COMPANY: Analog Devices Inc.			
TITLE: EVAL-ADuC7060 Schematic			
CODE:	SIZE:	DRAWING NO:	REV:
EVAL-ADuC7060QS			A1
SCALE:		SHEET: 1 OF 1

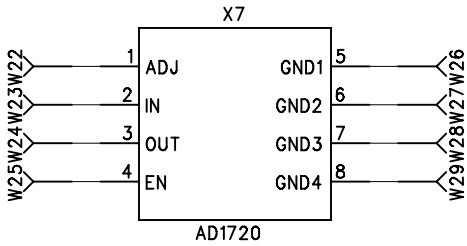
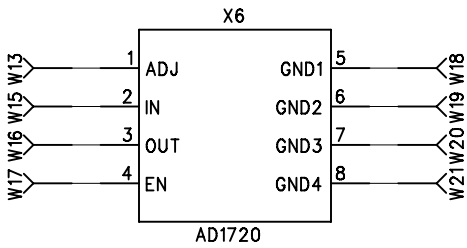
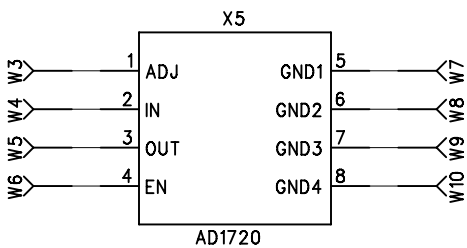
Include footprint for MOSFET, 6 x Res, 2 x CAP
